SERVICE BULLETIN

68

4

CANOPY LATCH CORRECT OPERATION INSPECTION

Fig 1

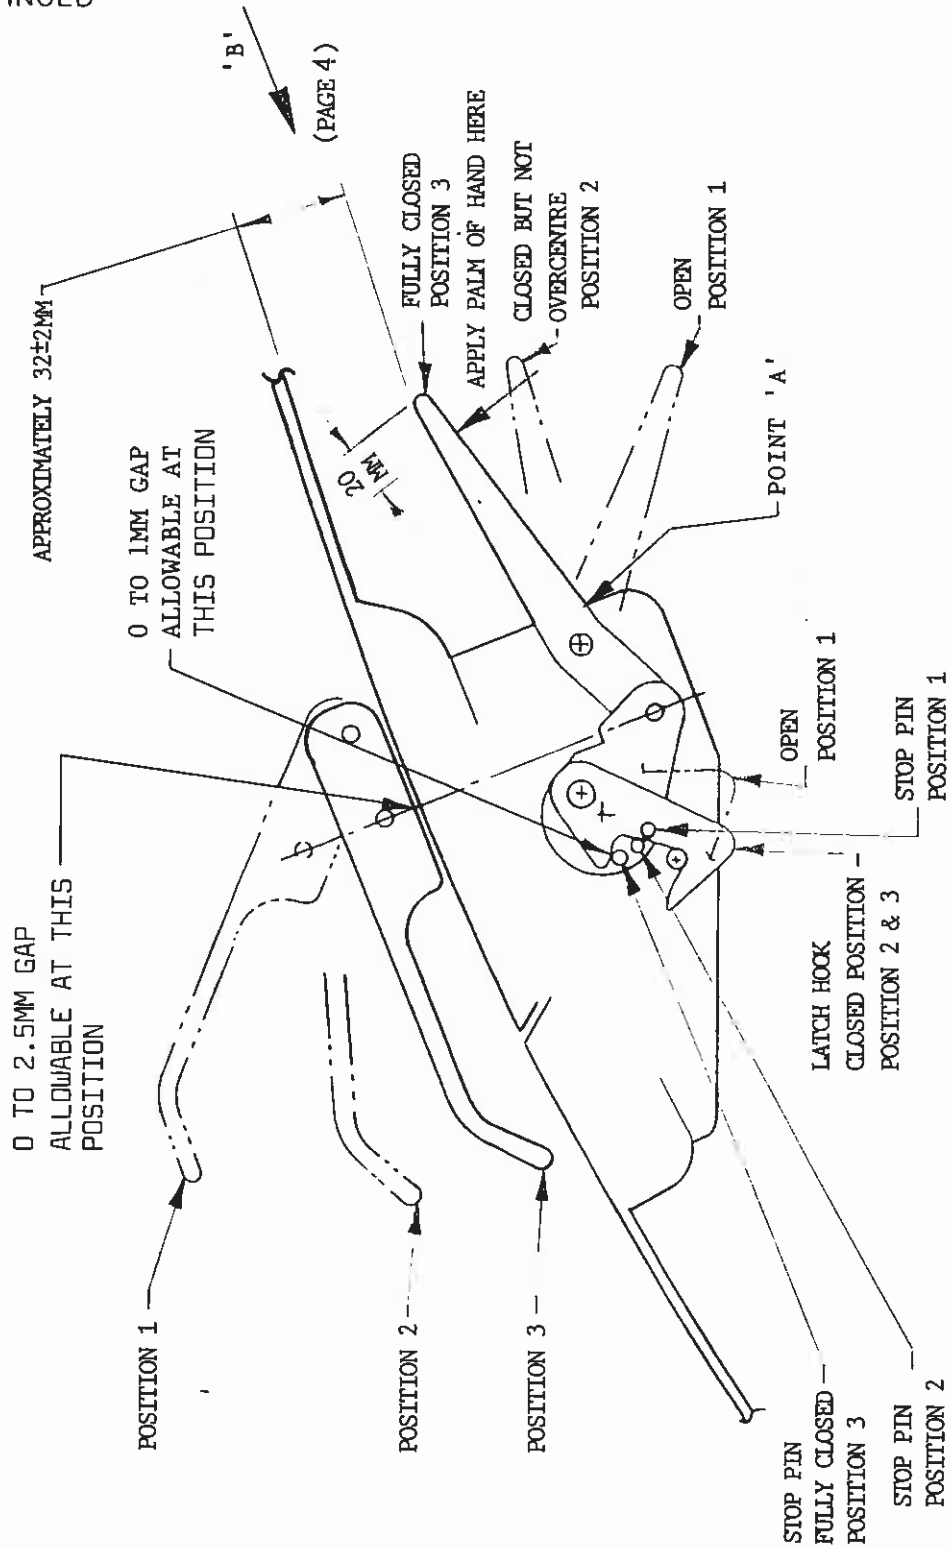
Canopy seal information added and 2.5mm gap at Para (ii) was 1mm. Fig. 1 altered accordingly.

Fig. 1 page 2 shows 3 positions of the canopy mechanism:

Position 1 - Open/Unlatched

Position 2 - Latched but mechanism not over centre

Position 3 - Correctly closed, mechanism fully over centre.

- (i) Remove canopy mechanism and latch covers
- (ii) Close canopy fully. Ensure internal handle is in its correct position and external handle is in its correct position, ie touching bush or no more than 2.5mm gap. Fig. 1.

- (v) Check closure. By positioning palm of hand at point indicated, ref. Fig. 1, push up latch handle, which should close with reasonable resistance but without using excessive force.

FIG 2
VIEW ON ARROW 'B' (REF FIG 1)

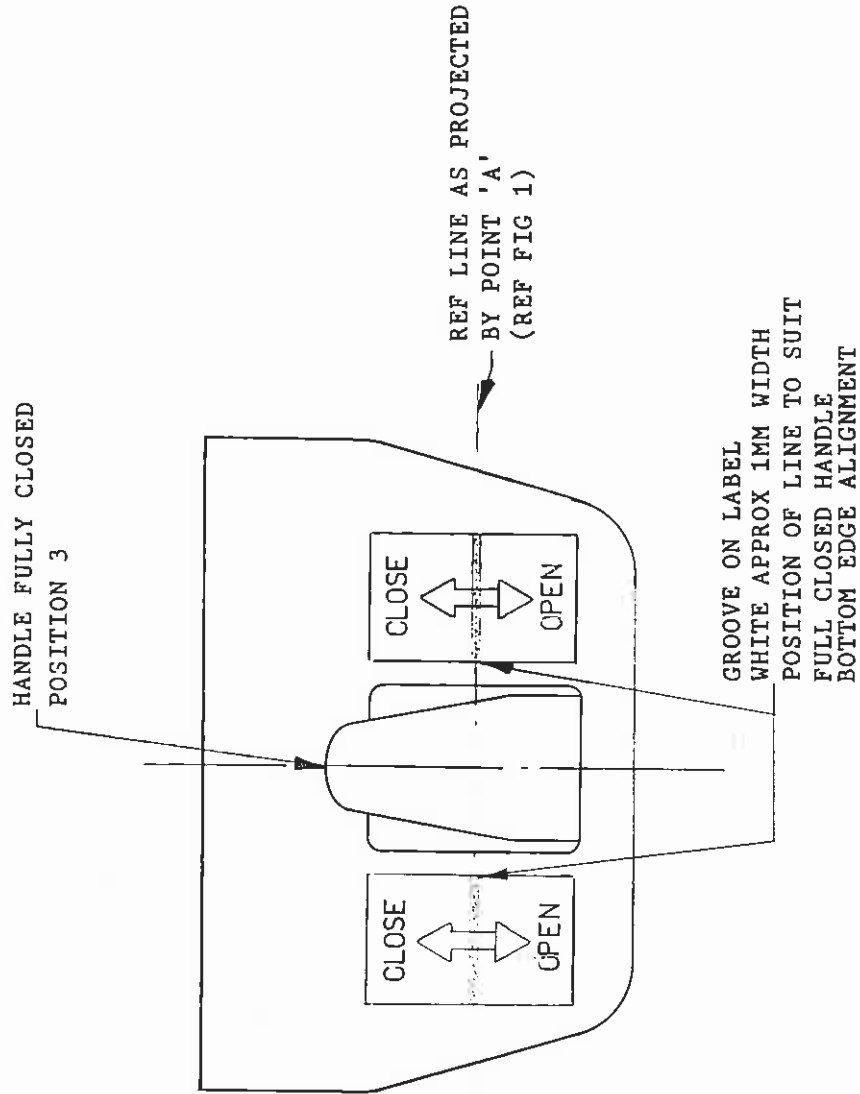
- (viii) When handle is fully closed, ie meets requirements of Fig. 1, mark a white line across both labels ref. Fig. 2 on line with handle lower surface (ie coincident with Point 'A' ref Fig. 1 & 2. The line may be obtained by running a hacksaw across both labels; a) deep enough to reveal white of label material or b) if base material is red, deep enough to hold white fill in wax, ie 0.25mm to 0.5mm.

When label is marked, it is to be identified in IPC Ref. Chapter 15 as Part No. T67M-17-351 Post Mod M666, Part No. T67M-17-319 to be annotated Pre Mod M666. Annotate Logbook Mod M666 incorporated.
- (ix) Providing the mechanism is correctly adjusted it should be obvious to the pilot that the latch mechanism has gone overcentre.
- (x) On completion of this SB, annotate Logbook SB68 complied with.
- (xi) Should a new canopy/seal be fitted, the latch mechanism inspection, as outlined in this Service Bulletin should be repeated up to 25 flying hours after installation.

FIG 3

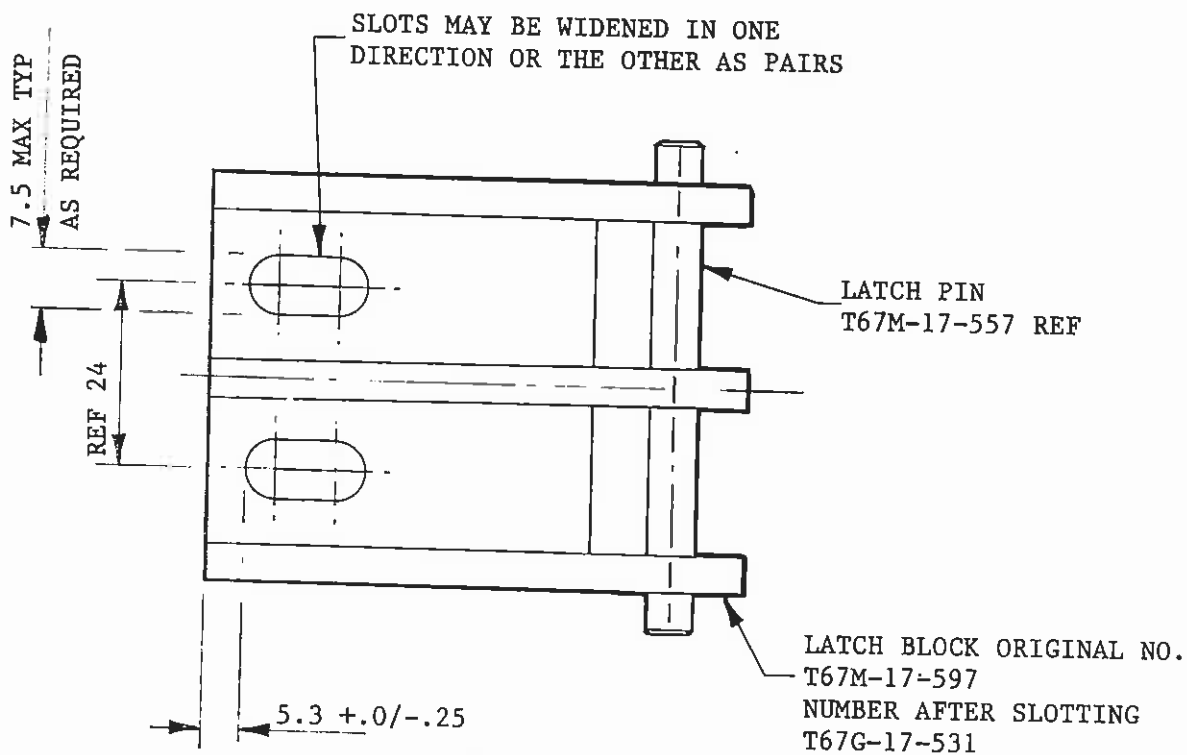
- (iv) If (ii) and (iii) cannot be met after adjustment, then it is acceptable to slot latch block Ref. Fig. 3. Suitably re-protect cut surfaces and re-identify block as Part Number T67G-17-531 Post Mod M713B. Annotate Logbook accordingly.
